Access Compliance Report Public Rights-of-Way (Curb Ramps)

Main Street: SIENNA_PKWY		Cross Street: WINDMILL_AVE		Location:	N
ADA ID: RPRK211109115242	Ramp Type: Type 1 - Perpendicular	Initial Pass/Fail: Fail	Overall Compliance: No	Severity Score:	30

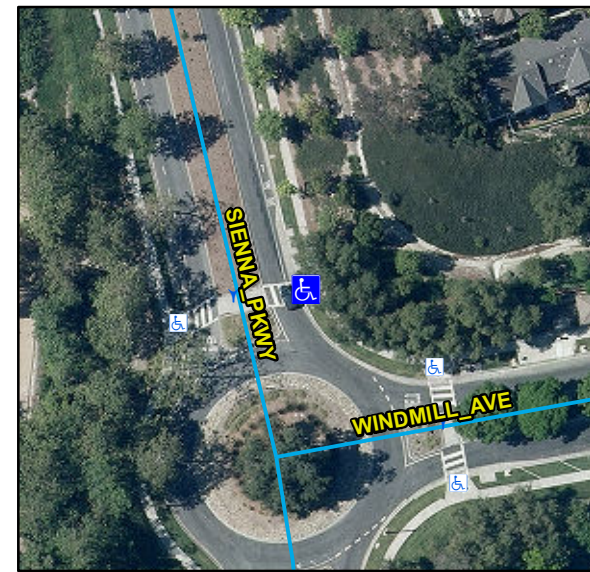
Compliance	Description	Data	Compliance	Description	Data
N/A	Ramp Length (in)	86	N/A	Flare Type LT	
Yes	Ramp Width (in)	48			N/A
No	Ramp Run Slope (%)	9.1	N/A	Flare Slope LT (%)	N/A
No	Ramp Cross Slope (%)	6.3	N/A	Flare Traversable LT	N/A
N/A	Landing Present	N/A	N/A	Flare Type RT	
N/A	Landing Length (in)	N/A			N/A
N/A	Landing Width (in)	N/A	N/A	Flare Slope RT (%)	N/A
N/A	Landing Run Slope (%)	N/A	N/A	Flare Traversable RT	N/A
N/A	Landing Cross Slope (%)	N/A	N/A	DWS Provided	N/A
N/A	Landing Movement Obstructed?	N/A	N/A	DWS Contrast	N/A
	Landing Movement Type	N/A	N/A	DWS Length (in)	N/A
N/A	Landing Shared	N/A	N/A	DWS Full Width	N/A
N/A	Clear Space	N/A	N/A	DWS Offset Left (in)	N/A
N/A	Clear Space To Crosswalk (in)	N/A	N/A	DWS Offset Right (in)	N/A
N/A	Marked Crosswalk 1	Yes	N/A	Marked Crosswalk 2	N/A
	Crossing 1 Direction	W		Crossing 2 Direction	N/A
	Marked Crosswalk 1 Width (in)	144		Marked Crosswalk 2 Width (in)	N/A

N/A	Ramp Inside Crosswalk 1	Yes	Yes	Ramp Inside Crosswalk 2	N/A
	Crossing 1 Slope (%)	2.3		Crossing 2 Slope (%)	N/A
	Crossing 1 Cross Slope (%)	6.2		Crossing 2 Cross Slope (%)	N/A
N/A	Gutter Ponding	N/A	No	Curb Slope	7.3
Yes	Gutter Lip Height (in)	0		Road Run Slope (%)	N/A
N/A	Gutter Run Slope (%)	N/A		Road Cross Slope (%)	N/A
N/A	Gutter Cross Slope (%)	N/A			
Yes	Overall Surface Condition: Acceptable		No	Perp Joint Present	No
	Cross Gutter Present?	No		Spandrel Present?	No
	Replace Cross Gutter?	N/A		Replace Spandrel?	N/A

Remove & Replace Entire Ramp.
